**AGENDA  
CITY OF LAKE WORTH BEACH  
PLANNING & ZONING BOARD REGULAR MEETING  
CITY HALL COMMISSION CHAMBER  
WEDNESDAY, MAY 27, 2020 -- 6:00 PM**

DATE: May 20, 2020  
TO: Members of the Planning and Zoning Board  
FROM: Alexis Rosenberg, Senior Community Planner and Andrew Meyer, Senior Community Planner  
THRU: William Waters, AIA, NCARB, LEED, AP BD+C, ID, SEED, Director for Community Sustainability  
MEETING: May 27, 2020

SUBJECT: **PZB Project Number 20-00900001**: Request by Jeffery Burns of Affiliated Development on behalf of 1017 Lake Ave, LLC for consideration of a Development of Significant Impact, Mixed Use Urban Planned Development, Major Site Plan, Conditional Use Permit, Sustainable Bonus Program Incentive and a Transfer of Development Rights Incentive to construct a transit-oriented, mixed-use, multifamily development within the Transit Oriented Development-East (TOD-E) and Artisanal Industrial (AI) zoning district. The subject properties PCNs are 38-43-44-21-15-500-0030; 38-43-44-21-15-500-0010; and 38-43-44-28-44-001-0000.

**SHEET TITLE:** SITE PLAN  
**SHEET NUMBER:** SP-1

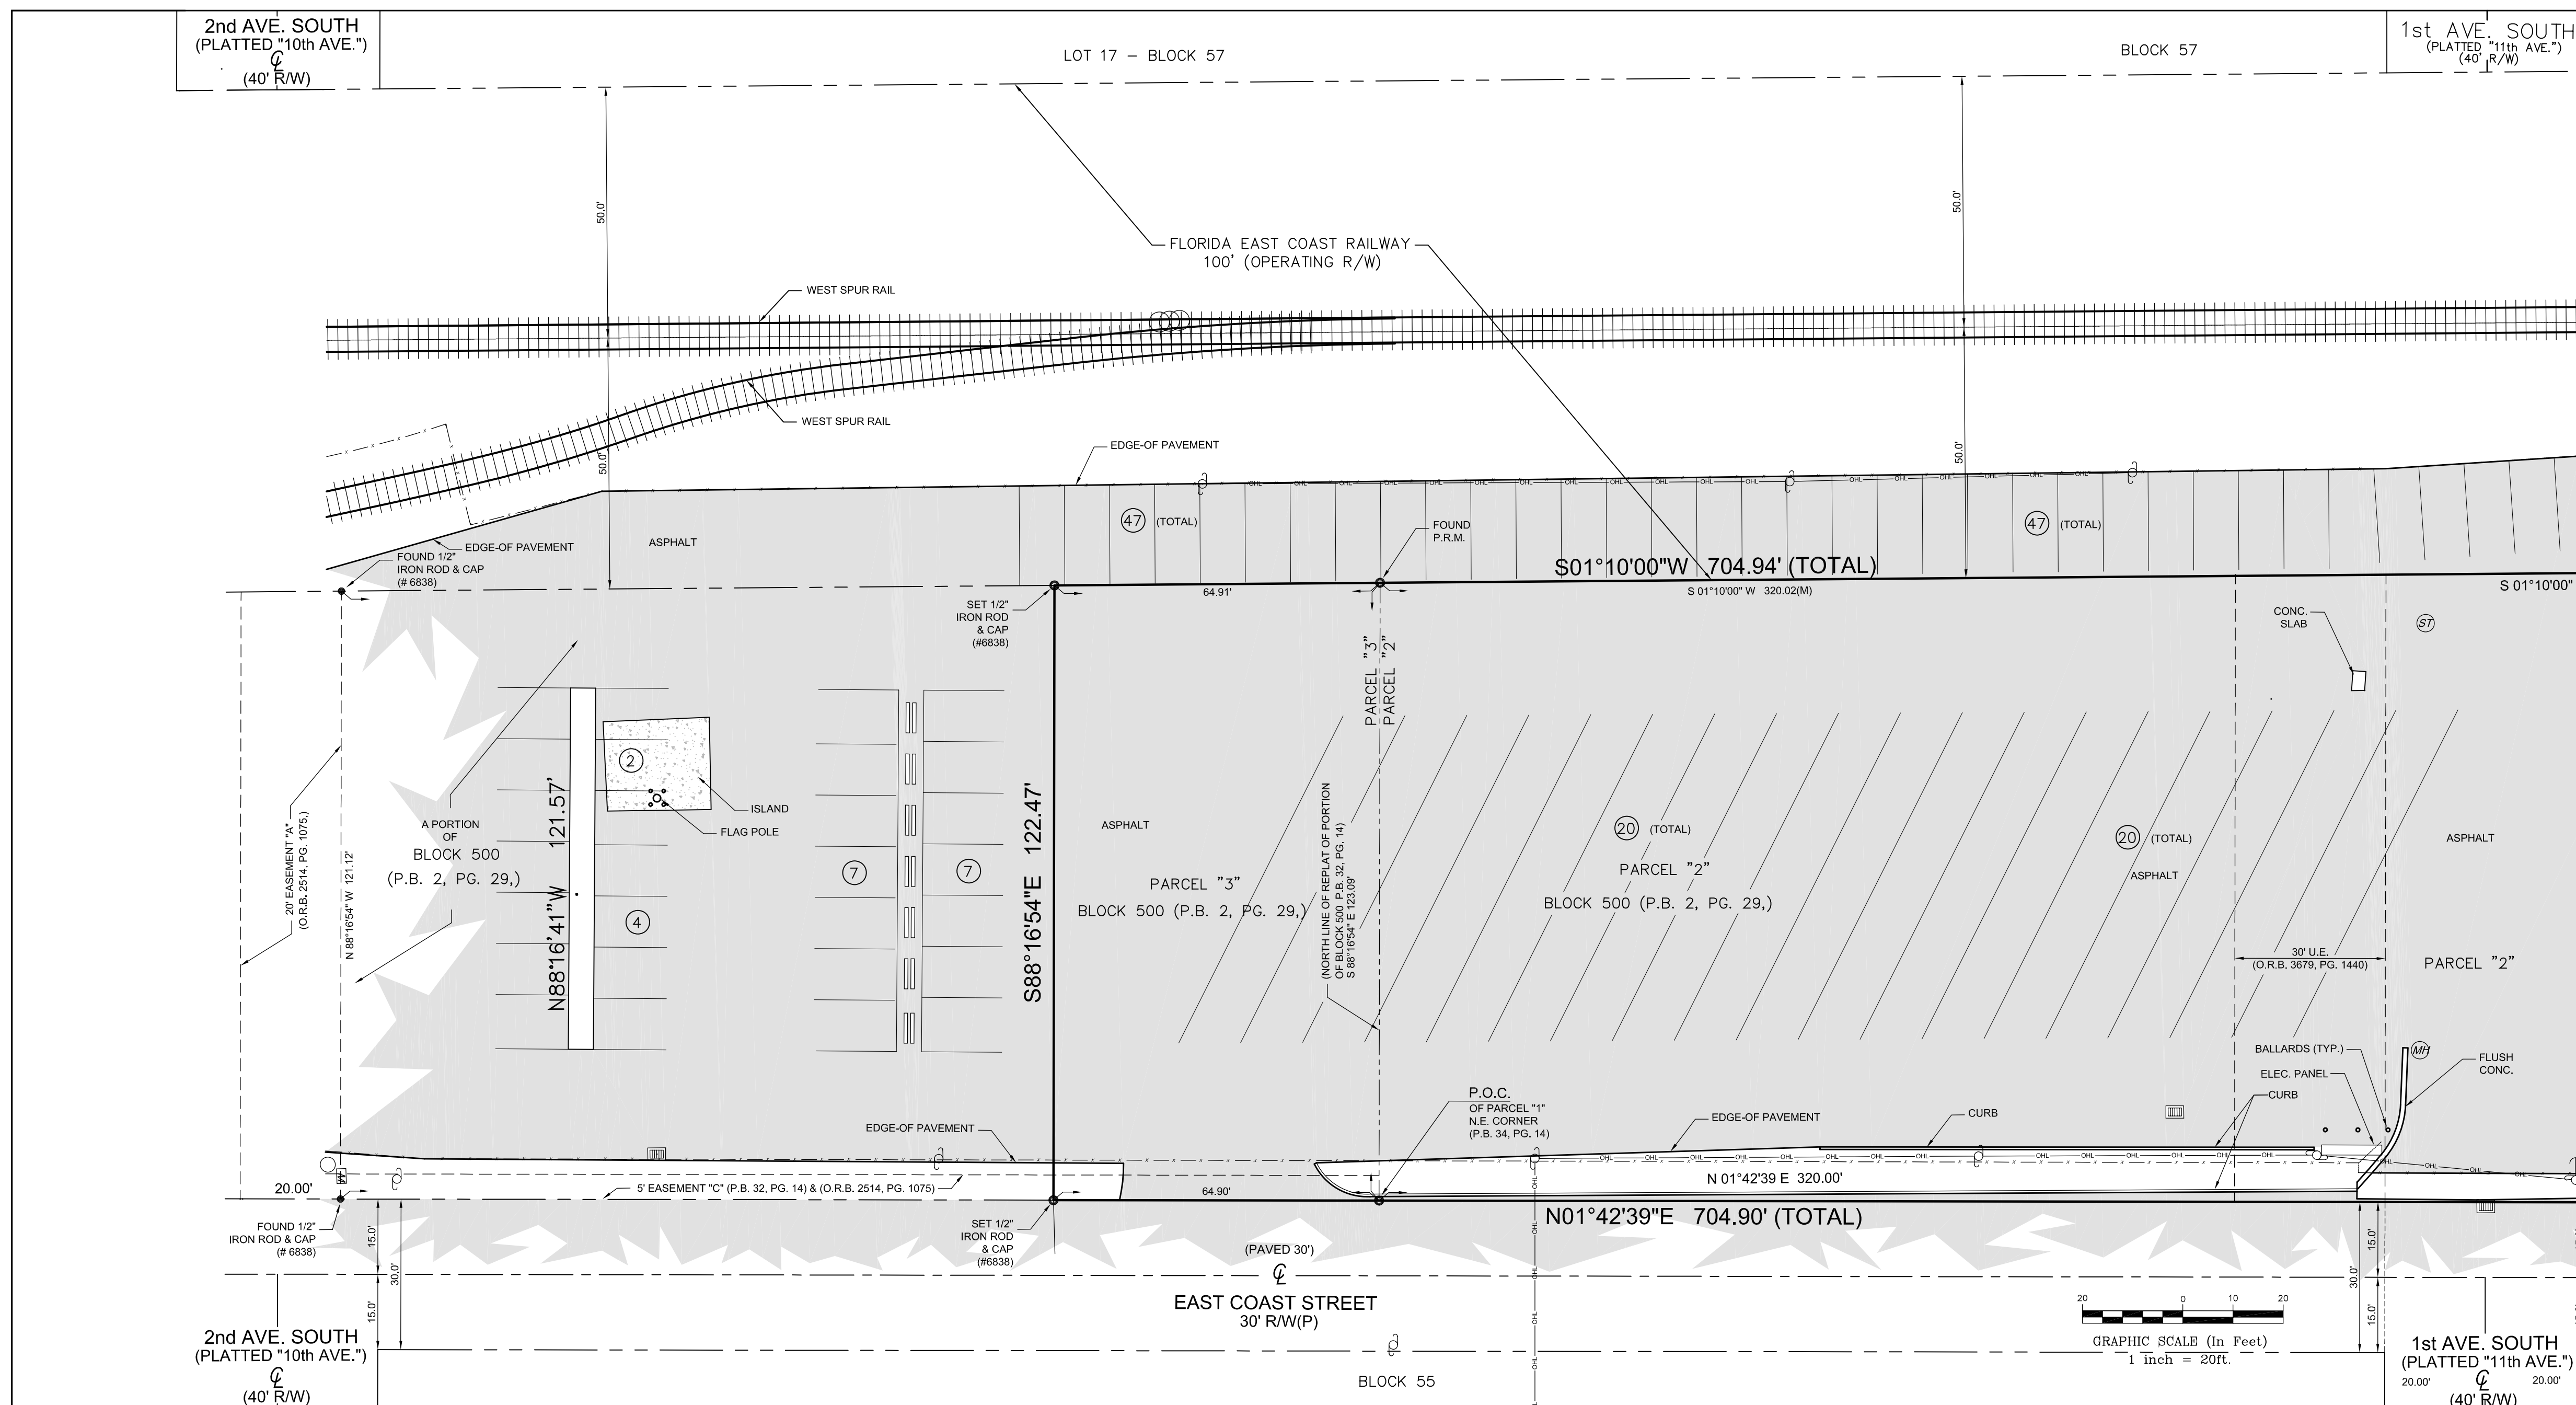
- c. Relabel the "pool court" on page A-2.0 to "open lawn," as that is the correct label for this area per page SP-1.
2. The proposed density for this project of 98.2 dwelling units per acre will not be effective and cannot be constructed until the transmittal to DEO for review and the adoption by the City Commission of the proposed concurrent amendment to the City's Comprehensive Plan to raise the base density in the TOD-E zoning district from a maximum of 50 dwelling units per acre to a maximum of 60 dwelling units per acre.

**Response:** *All setbacks have been shown. See Sheet SP-1*

**Response:** *Yes*
- 3. Will there be a security wall or fence with vegetation between the property and the FEC RR ROW?  
**Response:** *yes, see sheet SP-1 for notations*
